Hope Creek Generating Station  
Facility Operating License No. NPF-57  
NRC Docket No. 50-354

Subject: Response to Request for Additional Information  
Request for License Amendment - Extended Power Uprate

## Extended Power Uprate

## Response to Request for Additional Information

Figure 3.24-1 Loss of Feedwater Long Term Level Response

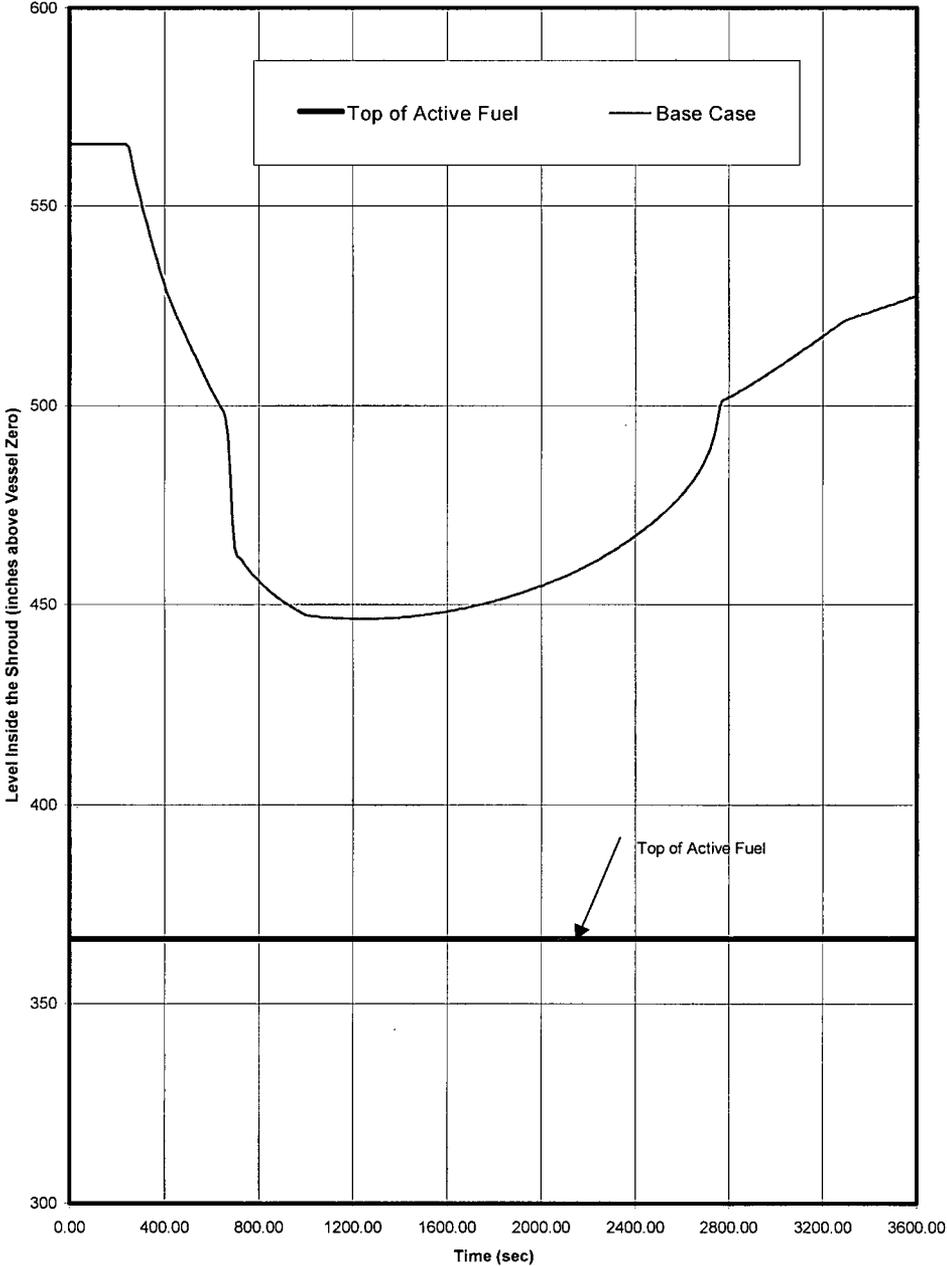
- 3.24 Please provide CPPU loss of feedwater flow and loss of one feedwater pump transient key parameter plots like Figures 9-1 to 9-4. For loss of feedwater transient, Hope Creek EPU mixed core (non GE-14 equilibrium) has different decay heat value than the one (GE-14 equilibrium) used in the analysis. How much does it affect the level recovery time? In terms of uncertainties, how does decay heat model used in your loss of feedwater flow analysis compare with the decay heat (decay heat  $\geq$  1979 ANS + 10%) suggested in ELTR1? Please also provide an estimate of lowest inside core shroud level in this transient. How does the calculated lowest level compare to Level 1? In loss of one feedwater pump transient, was Level 3 scram avoided?

In general, decay heat is not a strong function of fuel product line or fuel manufacturer. A comparison study had been performed to compare the ANS 5.1-1979 Standard decay heat result of a SVEA 96+ bundle with that of a GE14 bundle of comparable enrichment. The resulting differences were well within the calculation uncertainties, and hence provided justification that the HCGS EPU decay heat bases remain valid for a mixed core of SVEA 96+/GE14.

Furthermore, the Loss of Feedwater safety analysis for determining the margin to the top of active fuel uses the ANS 5.1 1979 decay heat + 10%, bounding all fuel types used at HCGS. The lowest level inside the core shroud was calculated to be 446" above vessel zero, which is more than 6 feet above the top of active fuel. A separate nominal Loss of Feedwater analysis was performed to compare the level in the downcomer to the operational limit for Level 1 as it is desirable to avoid Level 1 during a complete loss of feedwater. The downcomer level in this analysis was 417" above vessel zero, which was about 11" above the Level 1 operational limit.
